INNER WEST COUNCIL

DEVELOPMENT ASSESSMENT REPORT

Application No.	DA201900090
Address	127-133 New Canterbury Road, Lewisham
Proposal	To carry out partial demolition of existing premises and alterations and additions to the existing hotel for shop top housing comprising a hotel and 16 dwellings with basement parking accessed via Hunter Street.
Date of Lodgement	15 March 2019
Applicant	Koturic & Co. Architects
Owner	J.P.S Management Ent. Pty. Ltd.
Number of Submissions	10
Value of works	\$8,501,643
Reason for determination at Planning Panel	Heritage item Number of submissions
Main Issues	Acoustic impacts; Setbacks; Heritage; Signage; Hours of operations; and Waste collection/loading and unloading.
Recommendation	Approval with Conditions
Attachment A	Recommended conditions of consent
Attachment B	Plans of proposed development
Attachment C	Statement of Heritage Significance
Attachment D	Plan of Management

Figure 7: Precinct specific built form controls relevant to the site.

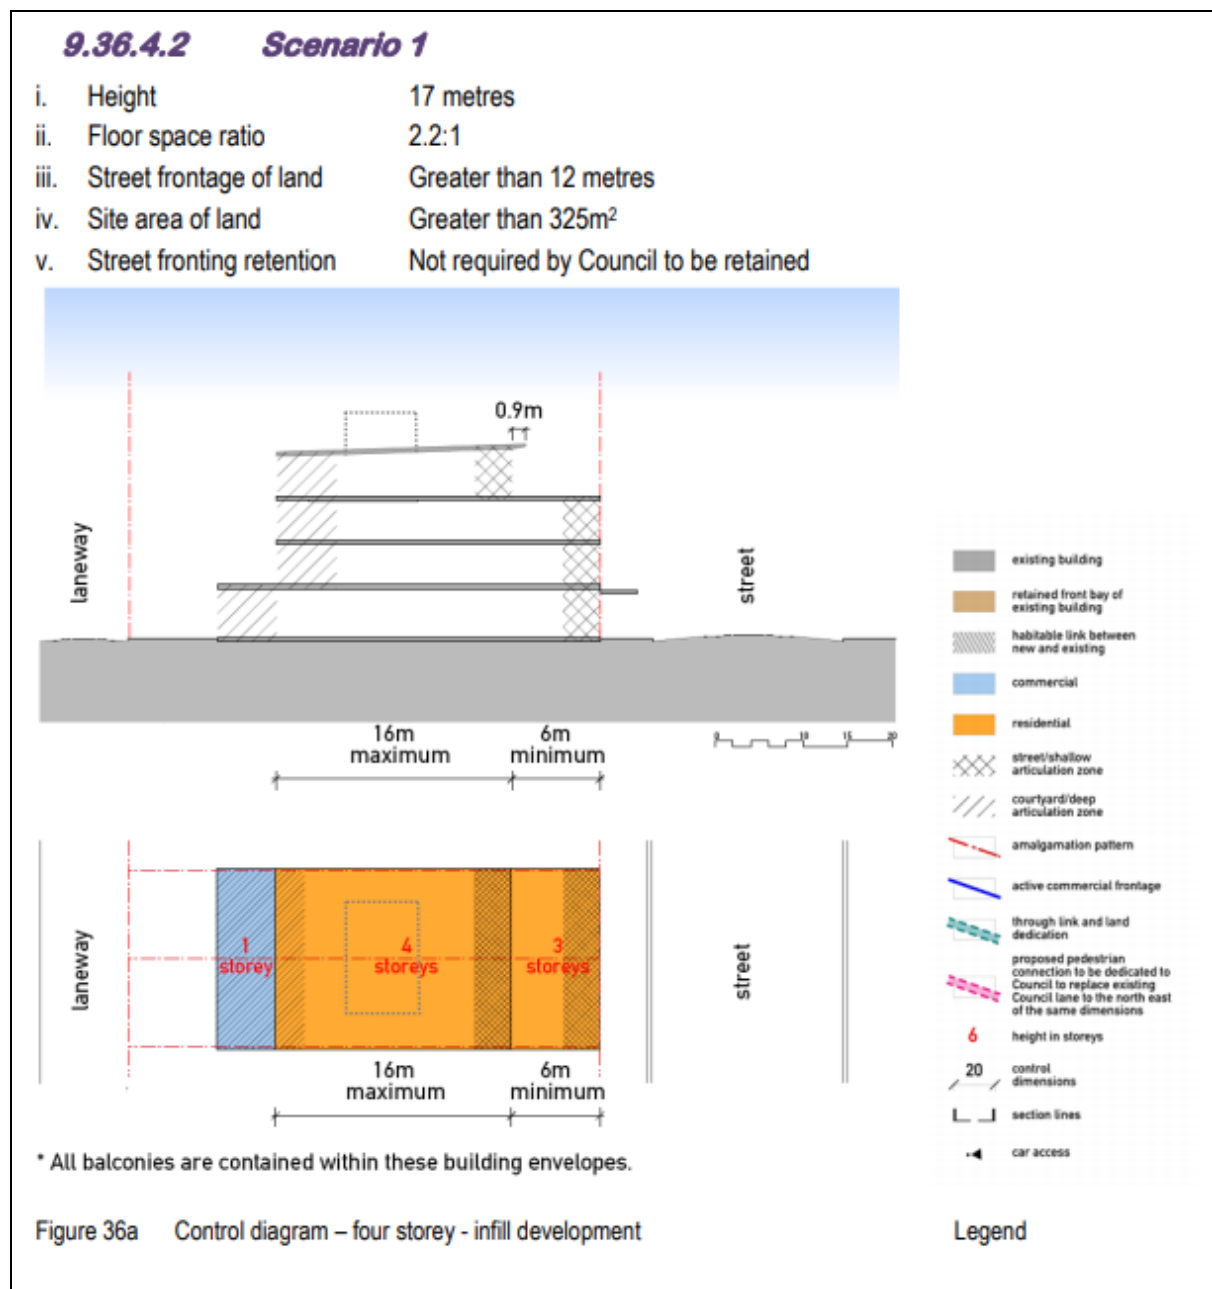
Accordingly the development of the site is guided by Scenario 1 that provides development guidelines to inform the building mass and form through the application of a building envelope shown in Figure 7 below.

Part 9.36 of MDCP 2011 envisages one possible form of development aimed at achieving the desired future character. Subject to the imposition of conditions, the proposed development can pose an alternative development option that is considered to be consistent with the relevant objectives for the area and allow the development potential of the site to be achieved.

The top storey balcony of Unit 15 has an approximately 600mm setback from New Canterbury Road, and a 3m building setback. This part of the plan requires a minimum 6m front setback to the balcony edge for the top level. In order to improve the desired visual subservience to the street wall and heritage item, it is a recommended condition of consent that the southern side of the balcony be reduced to a depth of 1m and for the associated eave overhang to be deleted. Suitably sized awnings or screens can be placed over the south-facing openings to achieve necessary weather protection if desired. It is recommended that the portion of the balcony to be deleted is required to be changed to a non-trafficable roof.
